Project Name: Harris Teeter at Ladys Island

**HARRIS TEETER AT LADY'S ISLAND**  
**CITY OF BEAUFORT – DRB CONCEPTUAL**  
**PROJECT NARRATIVE**  
**Submittal Date: September 2, 2015**  
**Meeting Date: September 10, 2015**

**CITY OF BEAUFORT  
DESIGN REVIEW BOARD  
Staff Report  
Meeting of September 10, 2015**

**Case Number:** 15-10 DRB.1  
**Project:** Harris Teeter on Lady’s Island  
**Property Address:** 163 Sea Island Parkway – NE Corner of Hwy 21 & Hwy 802  
**Parcel #:** R123 015 000 0587 0000; R200 015 000 0592 0000  
**Zoning:** General Commercial  
**Design District:** Lady’s Island Village Center Design District  
**Type of Review:** **Conceptual Review – New Construction**

Proposed Site  
Plan  
Concept 9

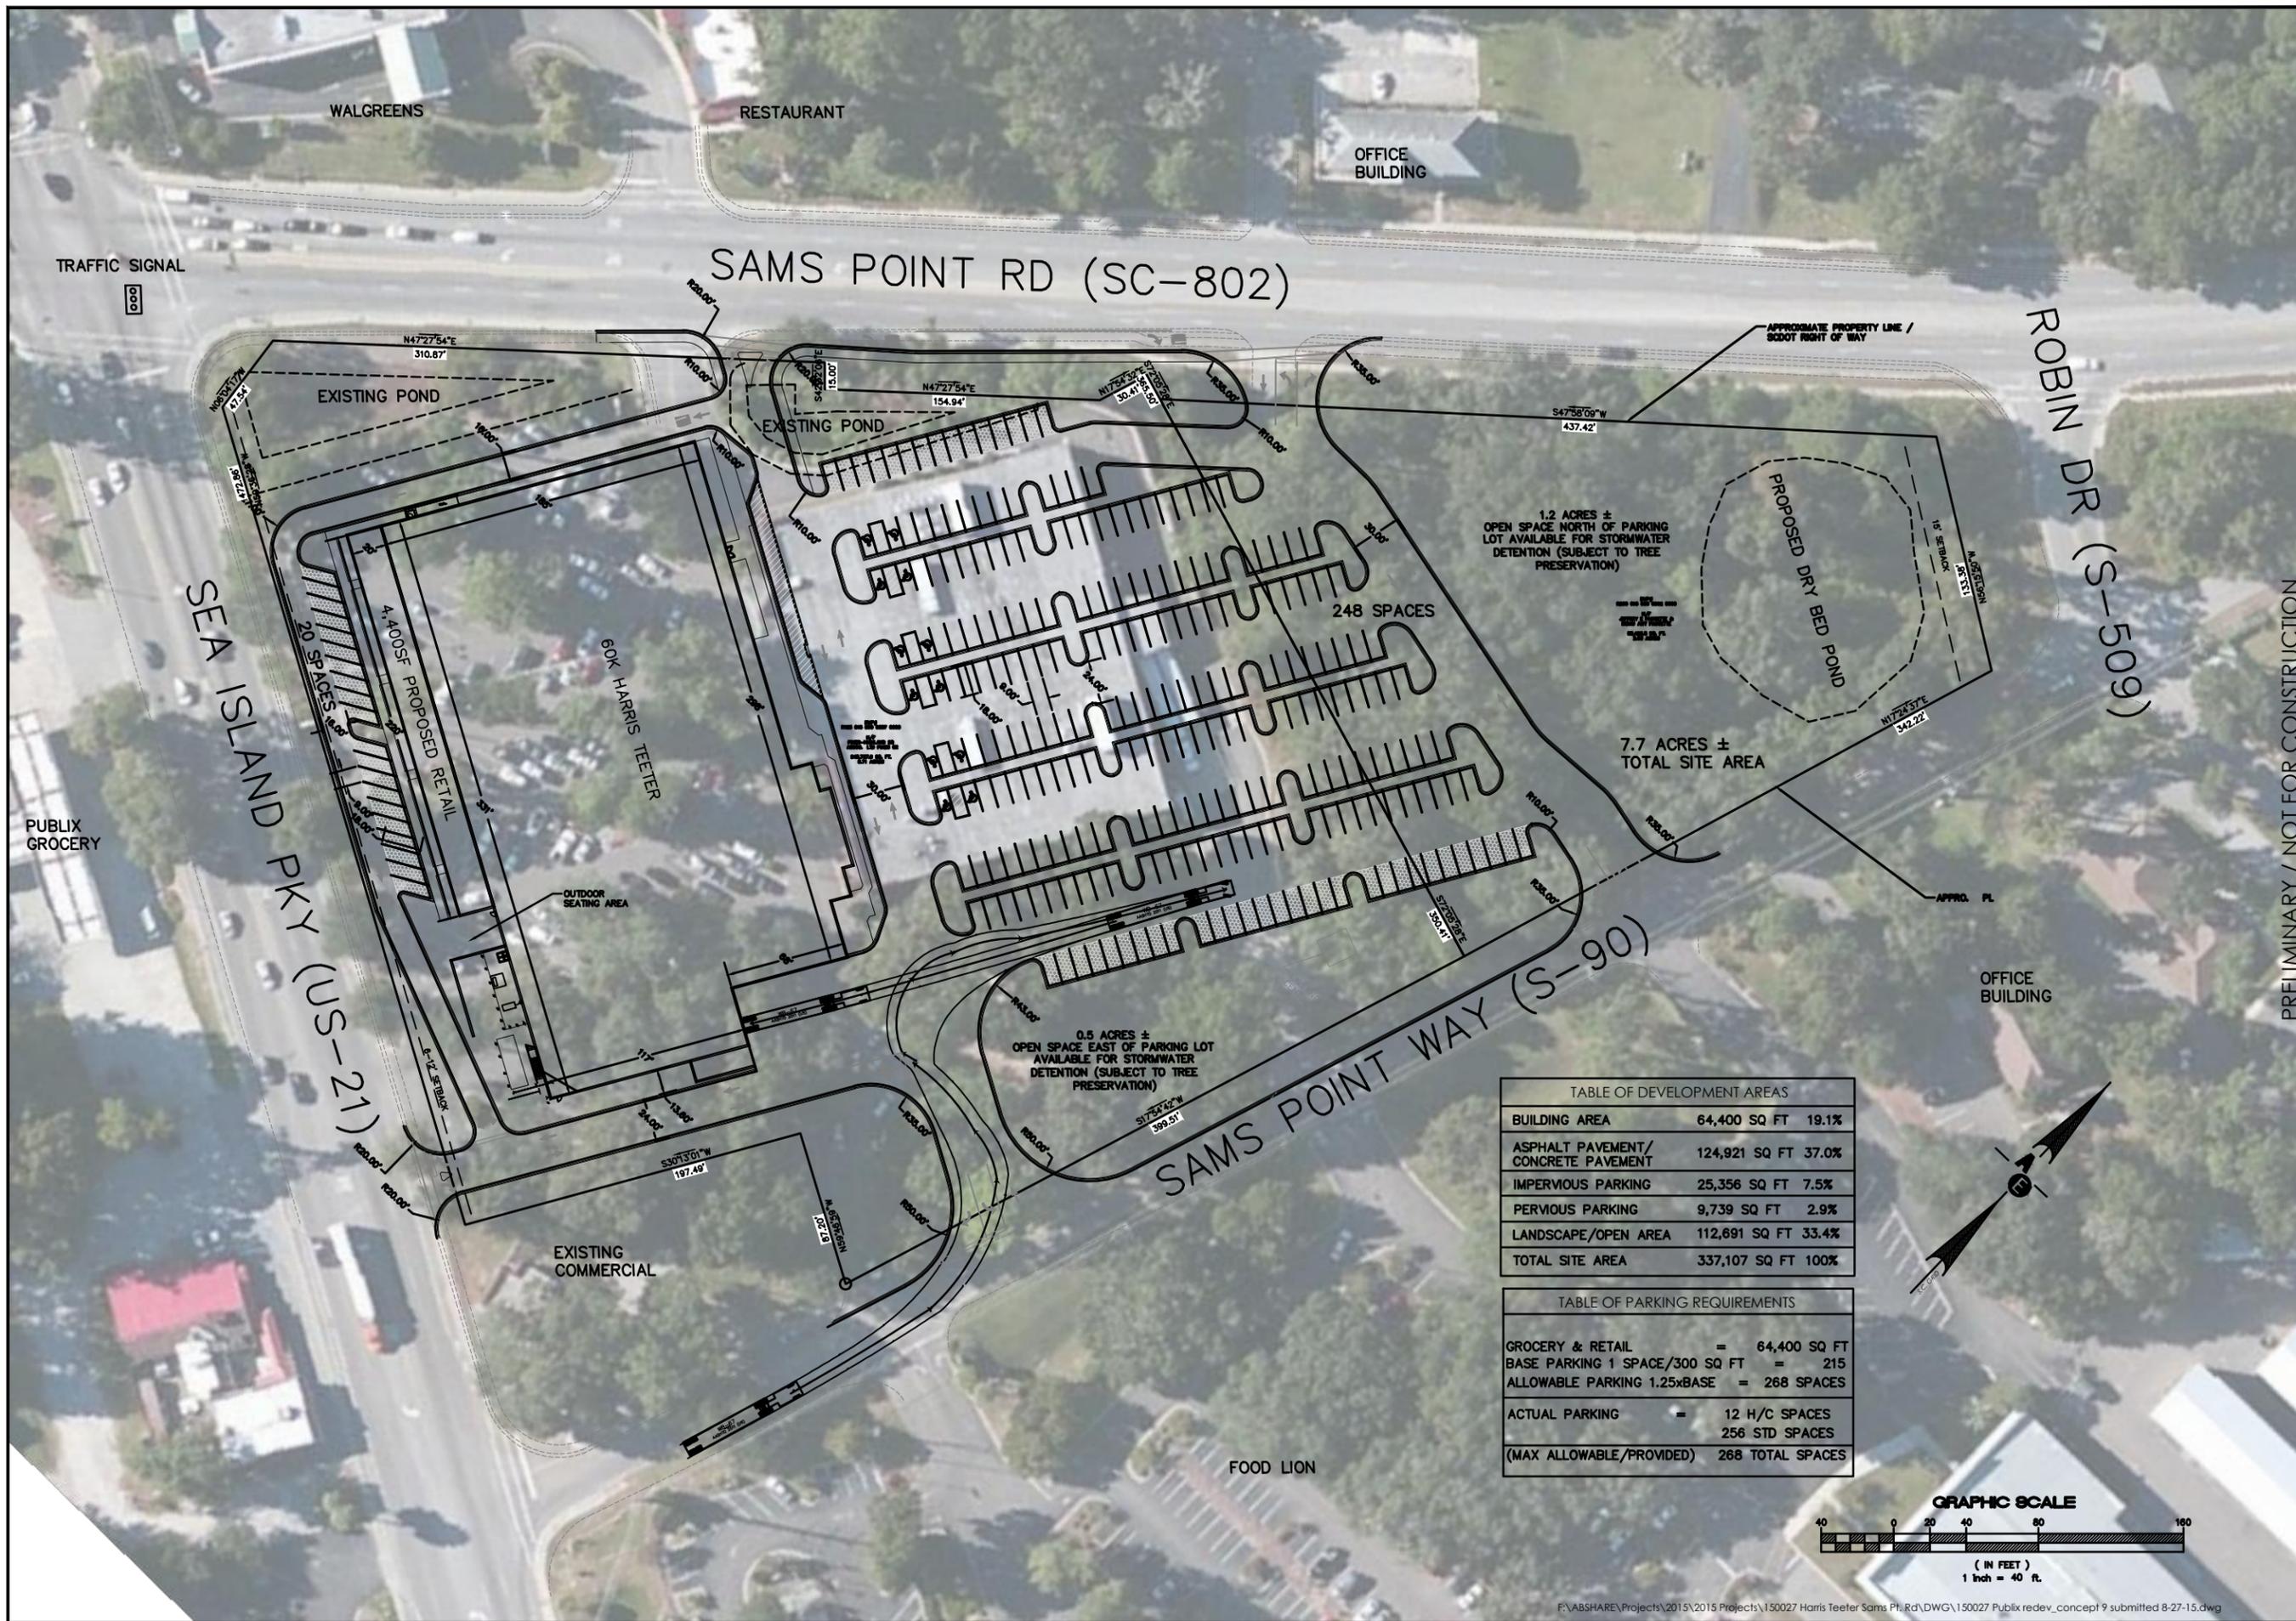
- **Vehicular Circulation:**
  - The curb cuts as shown, both existing, modified existing and new, appear that they will provide for much better vehicular access than what previously existed when Publix was located there.

- A 16', one-way slip road has been provided along Sea Island Parkway to provide access to the liner shops.
  - A traffic impact analysis will be required.

- **Pedestrian Circulation:** sidewalks exist on both Sea Island Parkway and Highway 170. Adequate internal sidewalks should be provided to connect to these sidewalks. In addition, a sidewalk should connect the line buildings with the front entry of the grocery store.

- **Slip Road Design:** Staff appreciates the on-street parking and sidewalk. Is it possible to provide tree wells as part of this as well? Particularly on the sides adjacent to the building.

- **Parking:**
  - There are 268 parking spaces shown, of which 65 appear to be pervious. This is within our ordinance requirements.
- **Trees:**
  - A formal tree survey will be required and some adjustments in the site plan may be required to accommodate existing trees.

- A certified arborist report will be required for any grand trees (>24") to be removed OR retained and impacted by construction.
- **Drainage:**
  - Is the intention to retain the existing drainage pond on the SW corner of the property, and to remove the one located further up Sam's Point Rd? And then, additional drainage, in the proposed locations, will be designed to accommodate the rest of the stormwater?

- Any stormwater management area located where it's visible from the public right of way must be designed and maintained as an amenity.
- **Future Drawings and Site Details Required:**

- Long, unarticulated facades are not permitted when visible from the public right of way, primary vehicle access point or parking area. The west façade, along Sam's Point Road, will need special attention and articulation to meet this requirement.
- Full architectural drawings will be required for future submissions.

Staff recommends that the DRB give Conceptual approval to the site plan with the following conditions:

- Tree wells and/or planting strips should be incorporated into to the slip road street section;
- Design of the site will accommodate the tree survey as much as possible once that is complete;
- Site design will be coordinated with building mass, form, and detail as appropriate in further phases. This includes but is not limited to entrances, walkways, outdoor elements such as seating areas, and equipment screening.
